STAFF REPORT

PLANNING BOARD MEETING

Case # 30-16: SITE PLAN REVIEW
Hathaway Collision Center
167 Potter Street
Map 82, Lots 108

Site Plan Review

PACKAGE STEEL SYSTEMS, INC.		Bob Hathaway	
PROJECT	Bob Hathaway	ANCHOR BOLT PLAN	
ID	Q1505-046	PRELIMINARY - NOT FOR CONSTRUCTION	
PROJECT		CSB	
ADDRESS	New Bedford, MA 02740	DATE: 6/16/16	DRAWING: ABL-T-1

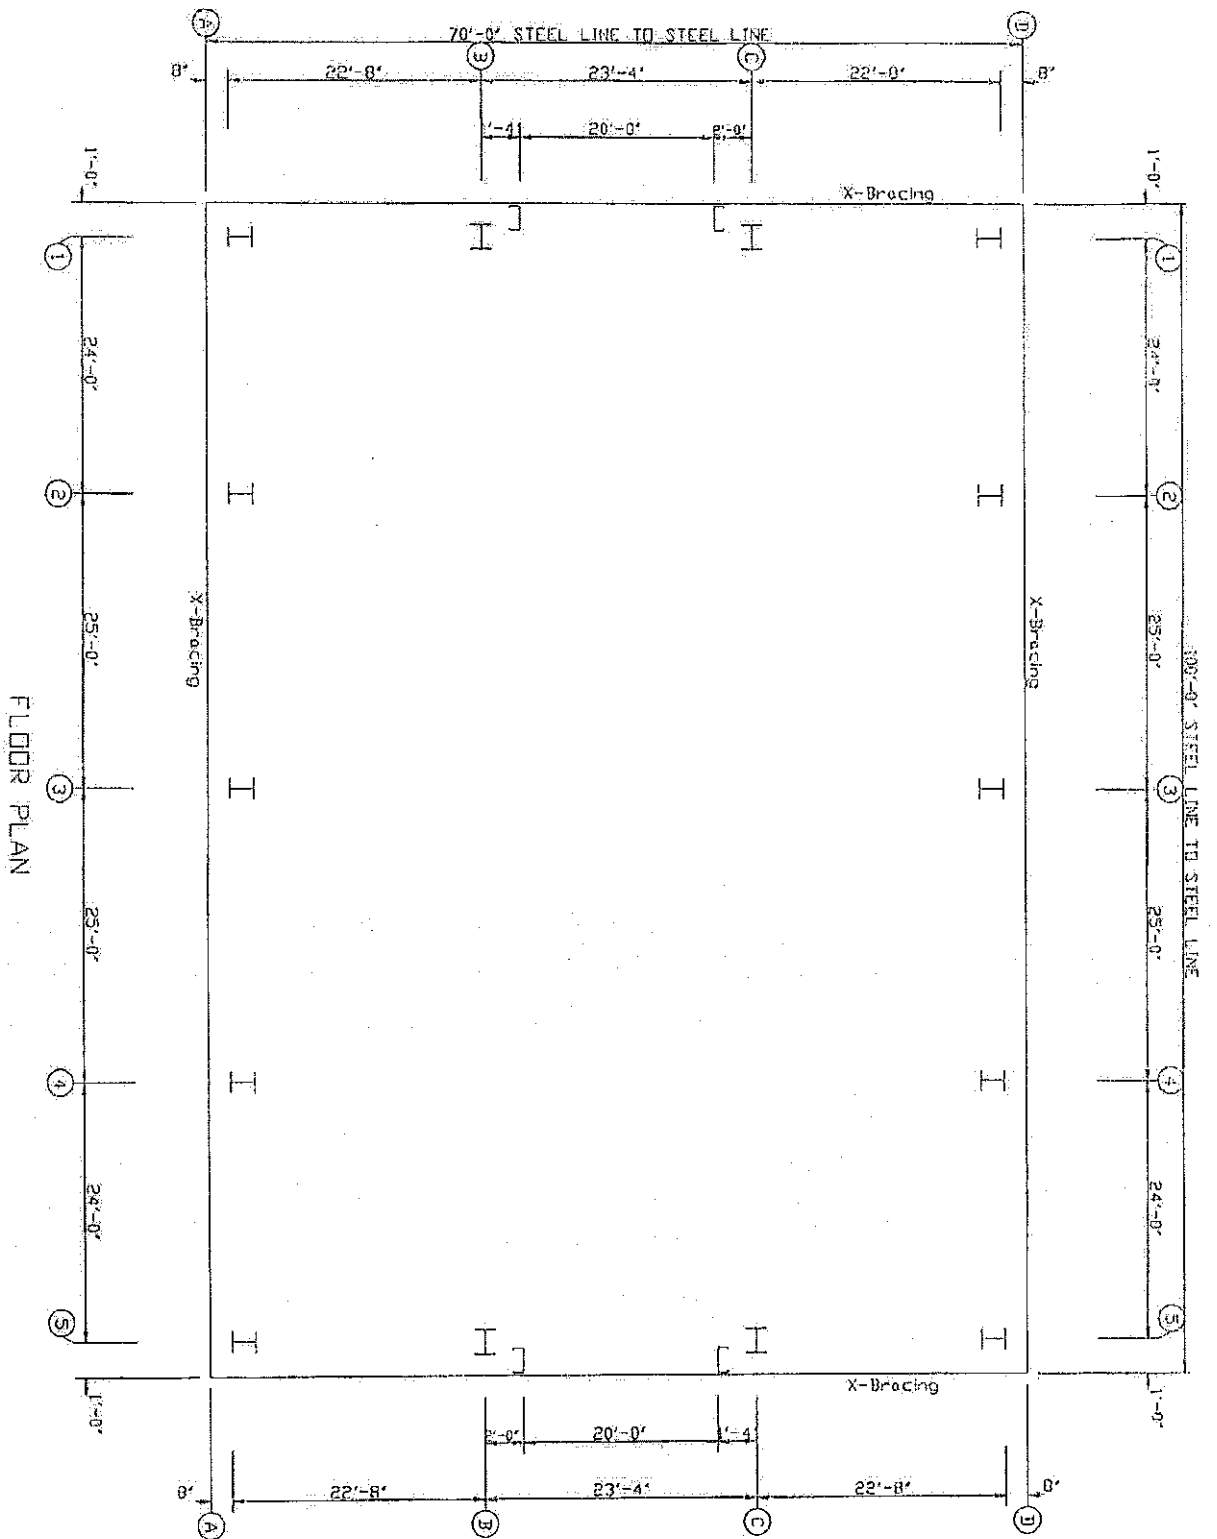
- The architectural plans have not been stamped or signed; staff recommends the applicant be reminded of the requirement to have the plans stamped by a registered architect as stipulated under §5440 of the city's zoning ordinance.

SL-1

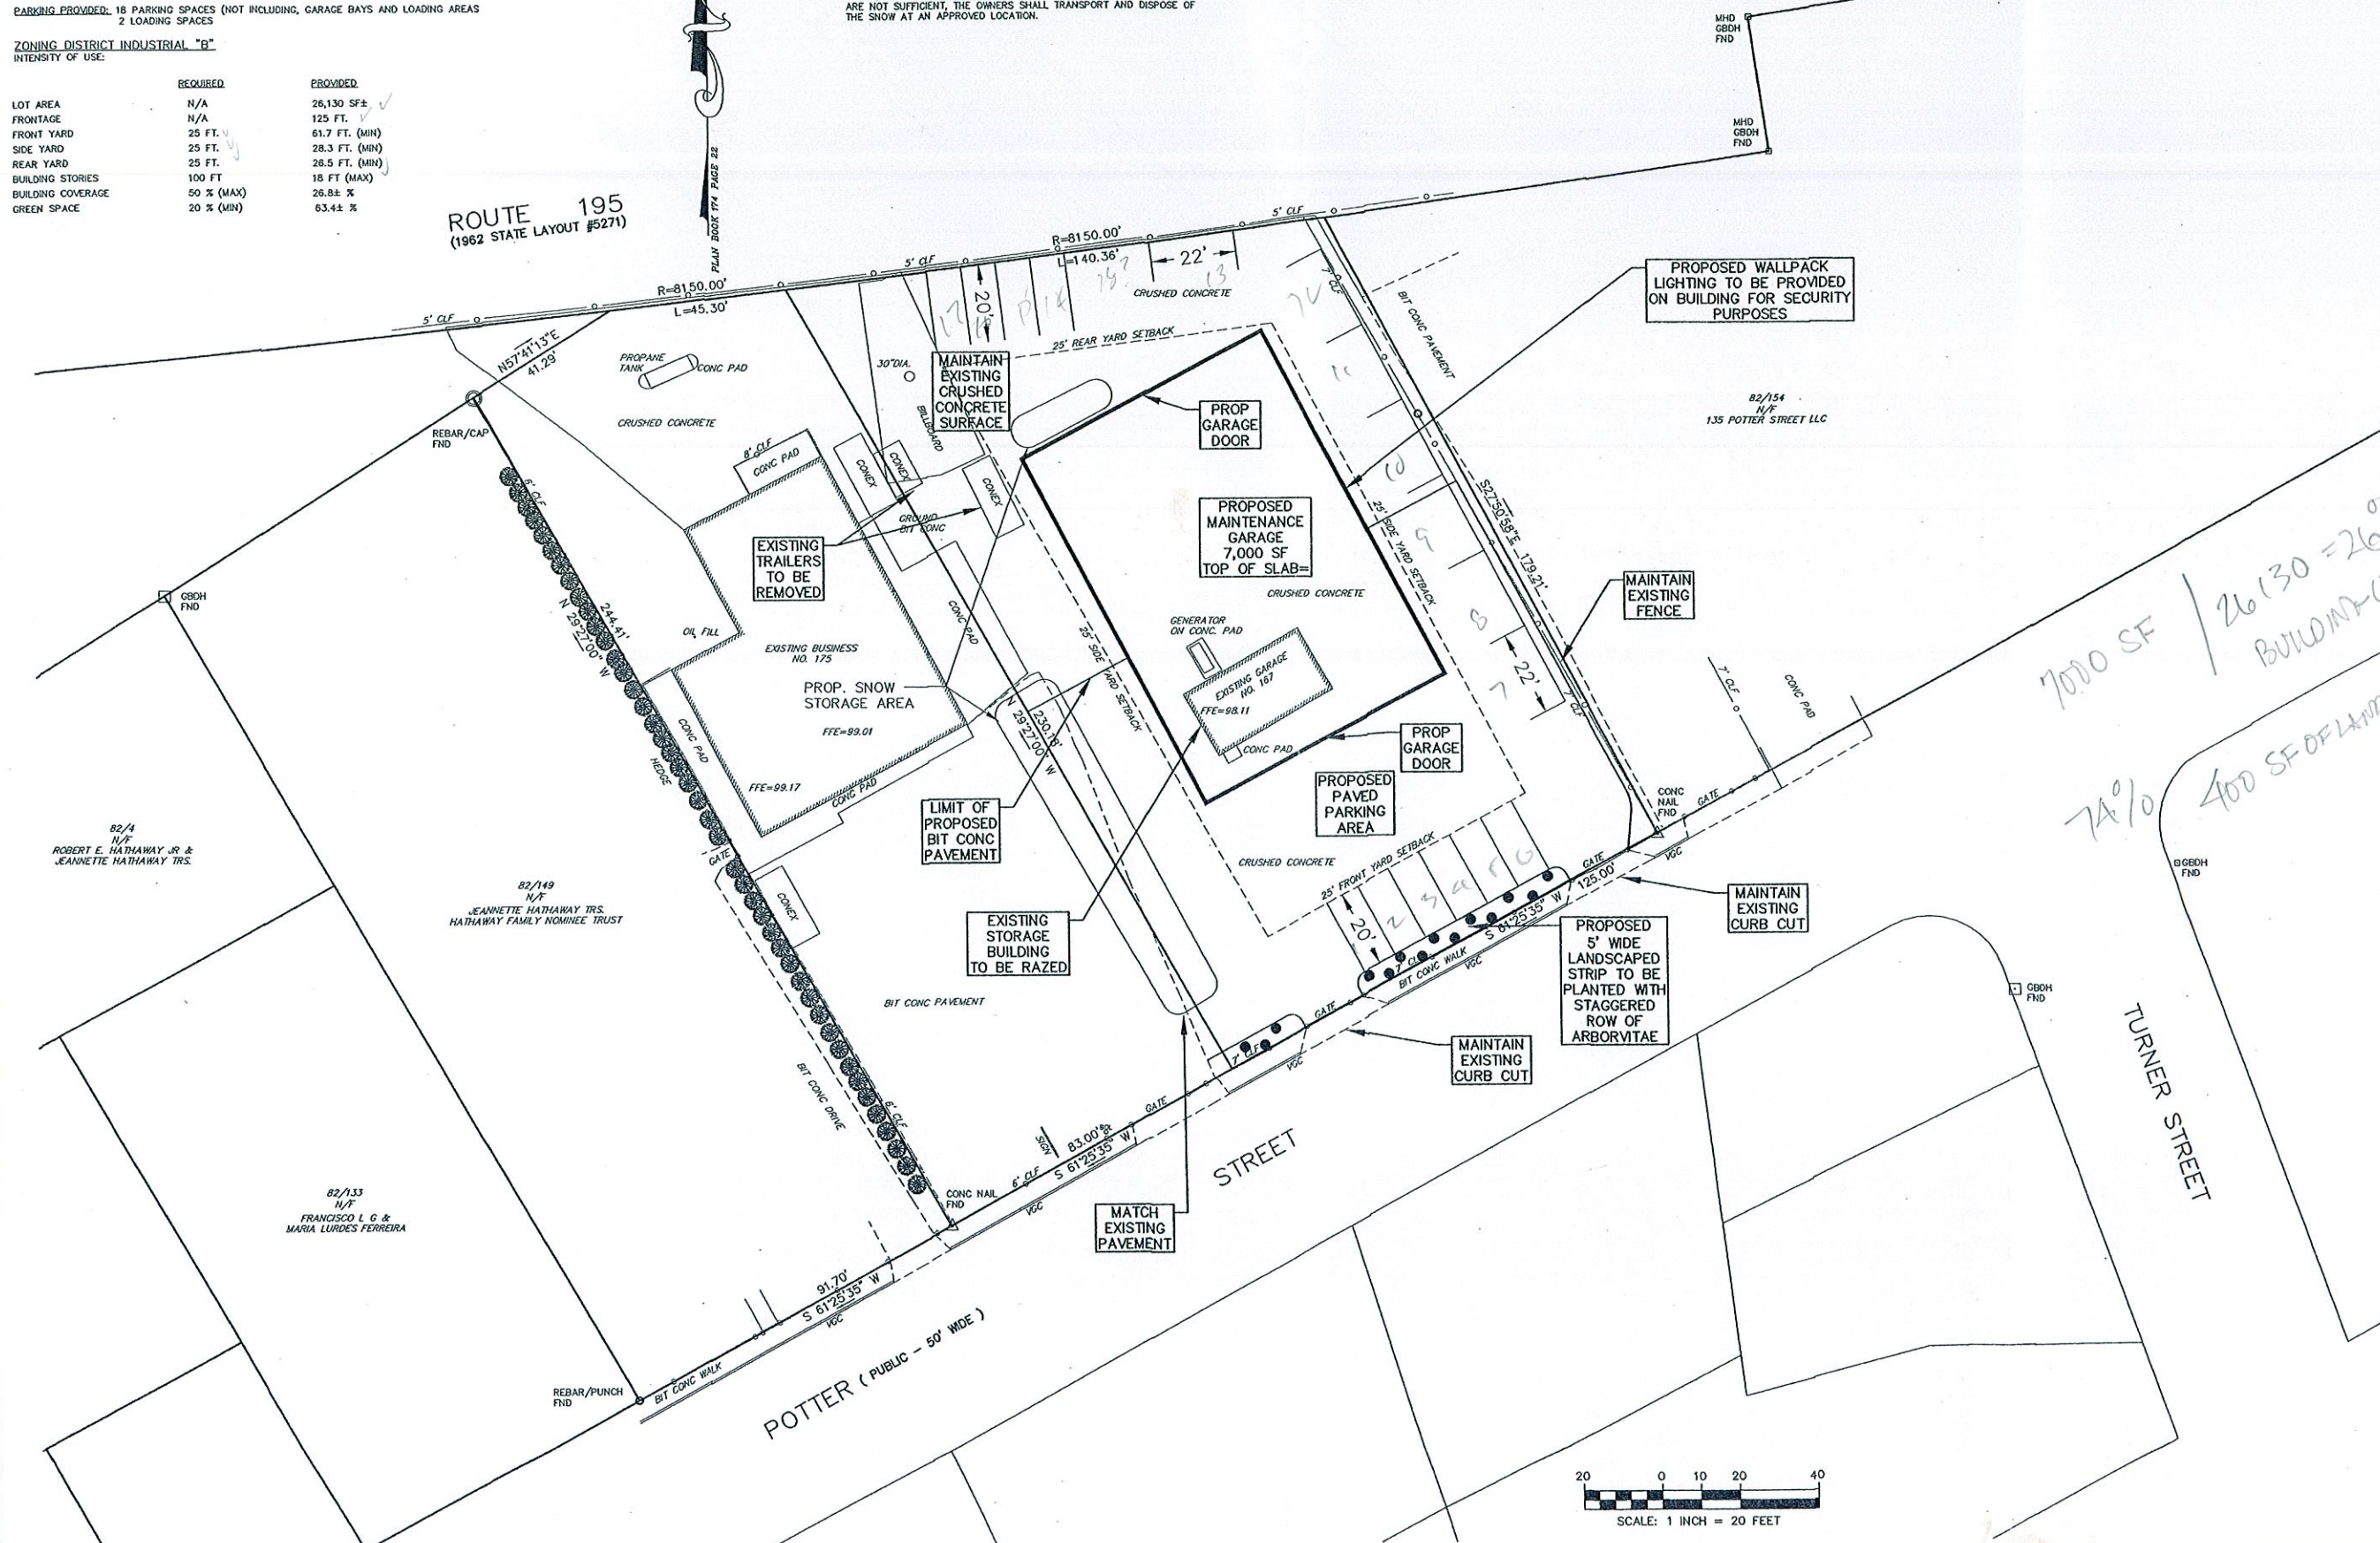
The proposed use requires eighteen (18) parking spaces, which are shown on Site Layout and Landscaping Plan sheet SL-1 with parking dimensions in conformance with regulations. However, aisle width at the east elevation of the building does *not* meet the stipulations of twenty-two (22) feet. For public safety reasons, the applicant should confer with the Fire Department and receive the Fire Marshall's sign off of the circulation plan. It is assumed that loading will occur inside the structure.

Omitted from this plan sheet is ADA parking for clients/customers. One ADA compliant space should be illustrated on the site plan to satisfy **521 CMR 23.00: PARKING AND PASSENGER LOADING ZONES**.

5. That a revised Landscape Plan be presented for approval by the Planning Board or its agent the Acting City Planner.
6. That Architectural Elevation drawings signed by the consulting architect be presented for review and approval by the Planning Board or its agent the Acting City Planner.
7. That the plans be revised to show benchmark locations based on USGS NGVD, with year, as required by the Planning division Site Plan Review Application Checklist .
8. That one ADA compliant space should be illustrated on the site plan to satisfy 521 CMR 23.00: PARKING AND PASSENGER LOADING ZONES.
9. Aisle width at the east elevation of the building does not meet the stipulations of twenty-two (22) feet. For public safety reasons, the applicant should confer with the Fire Department and receive written approval of the proposed circulation plan.

EROS-1

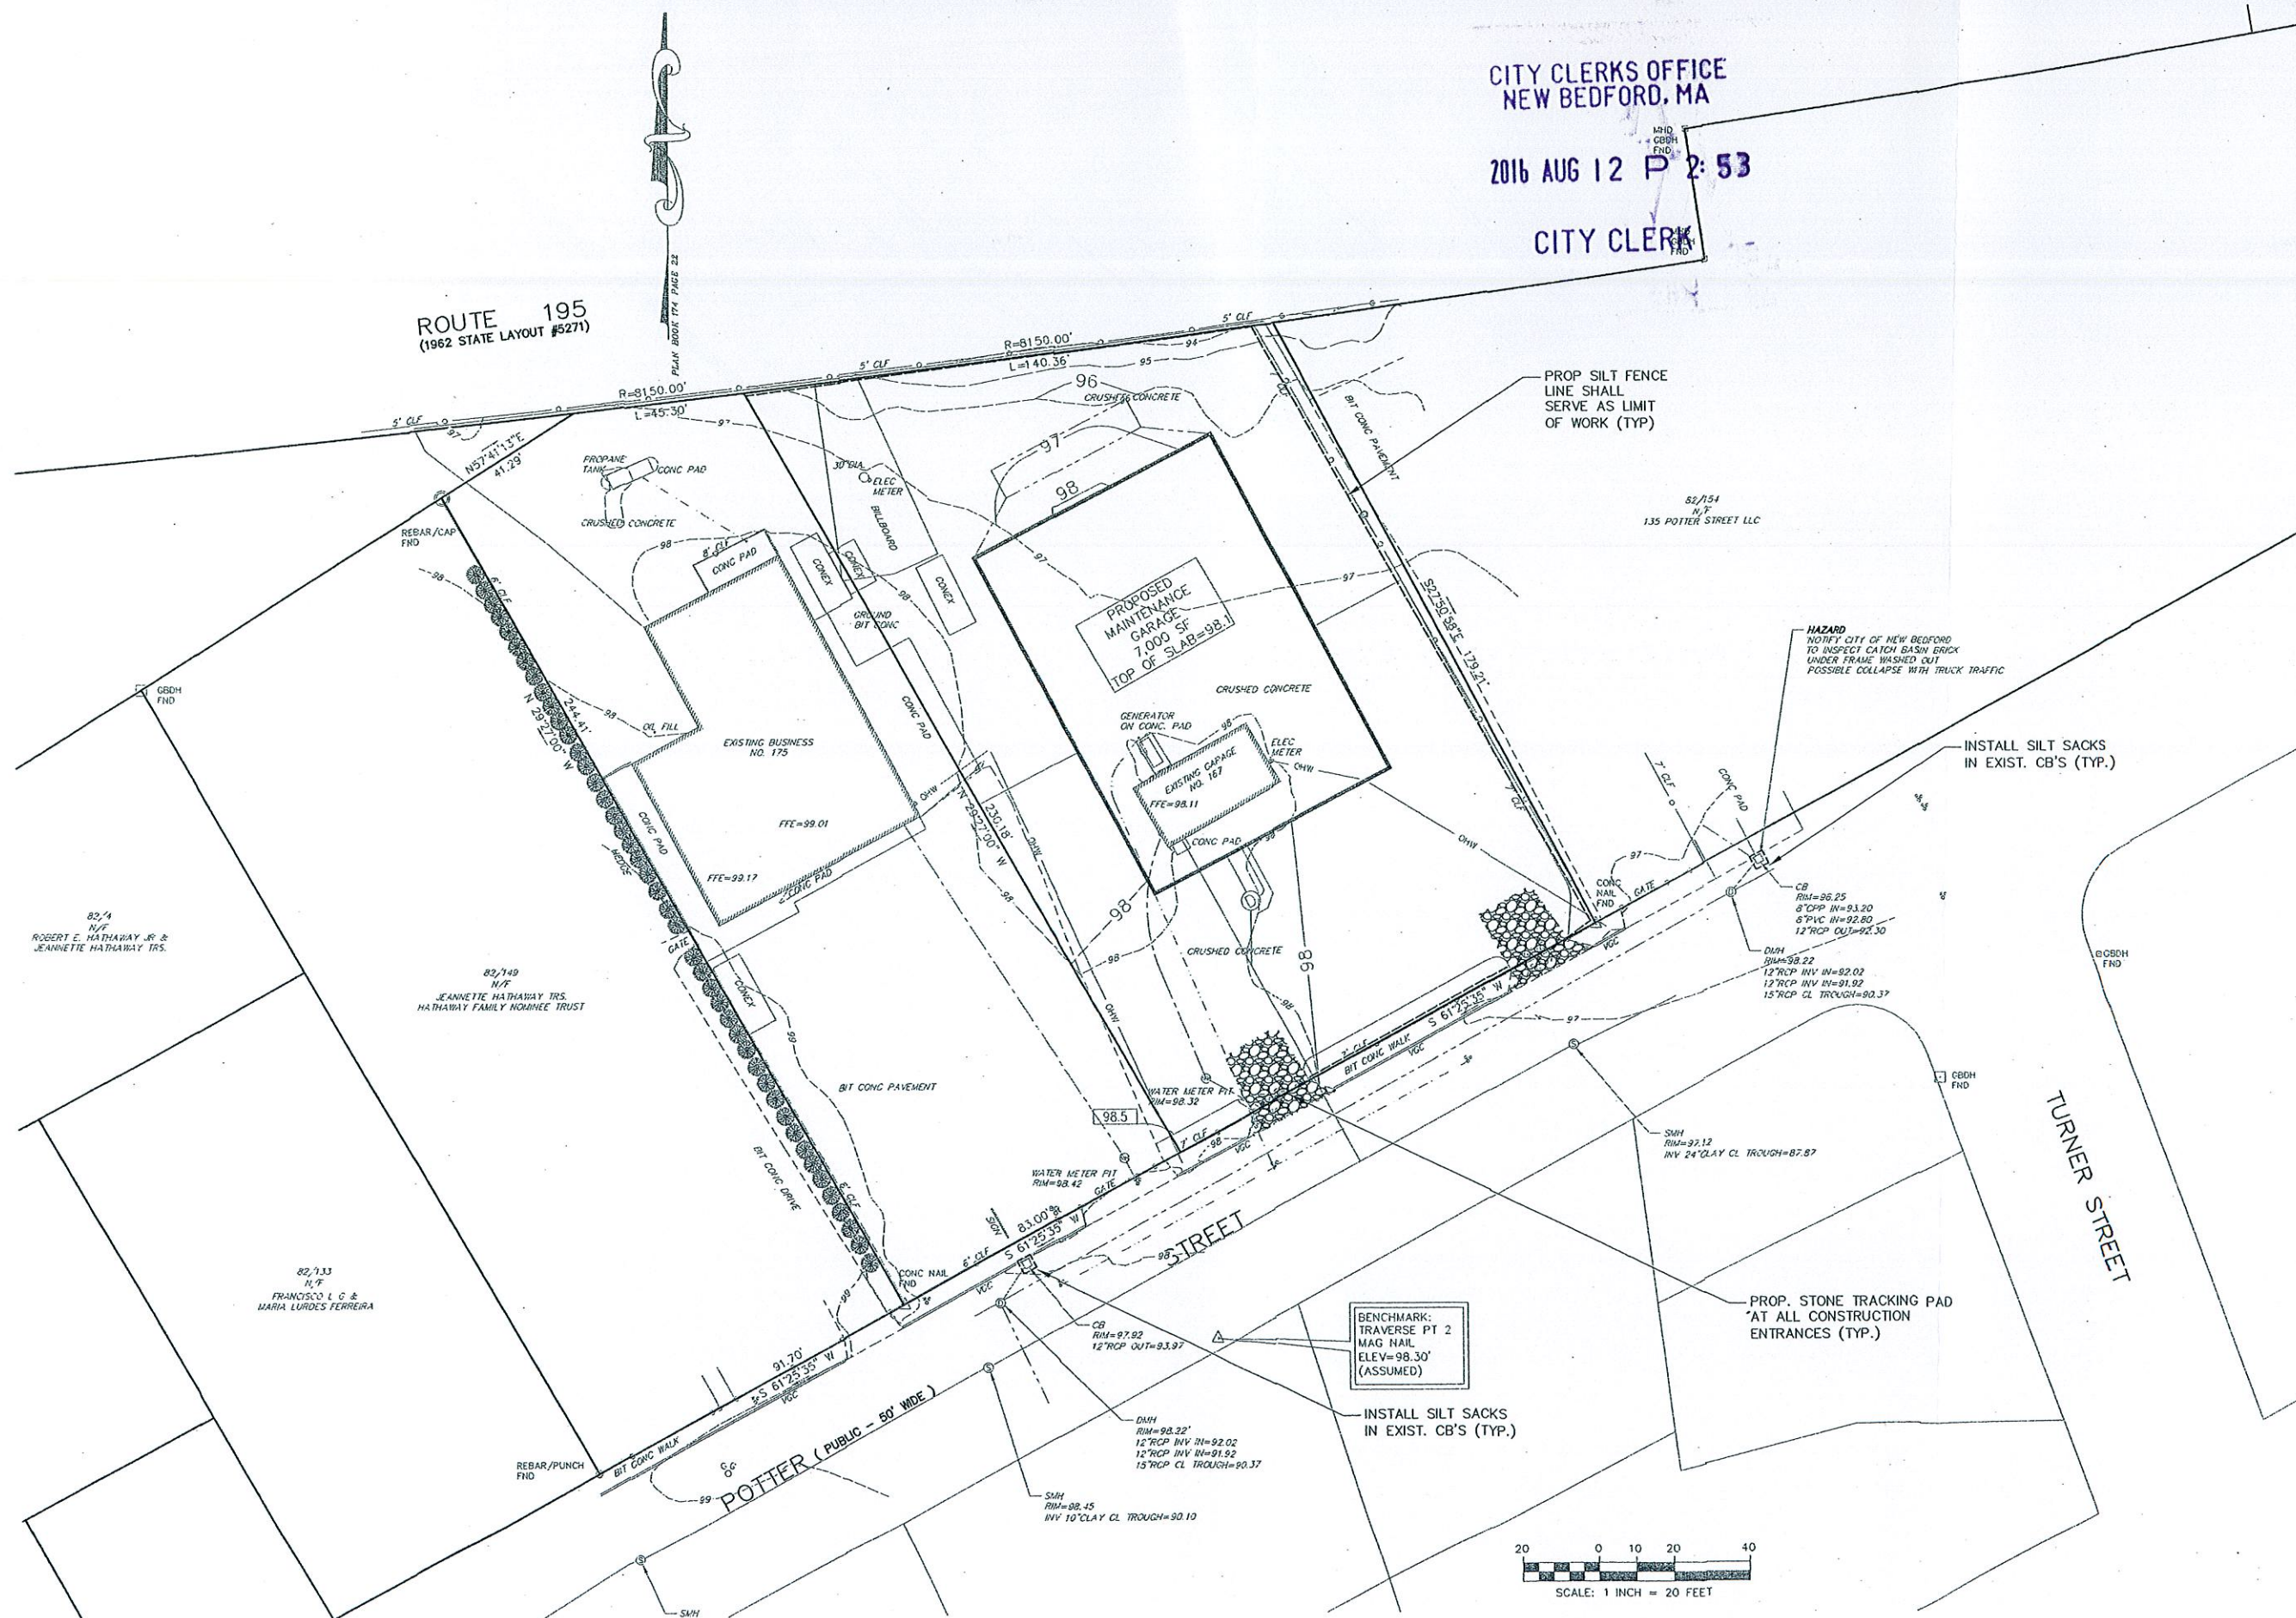
- Plans calls out a Hazard Note that states: *“Notify City of New Bedford to inspect catch basin brick under frame washed out possible collapse with truck traffic”*. The Board may wish to have the applicant elaborate on this comment.
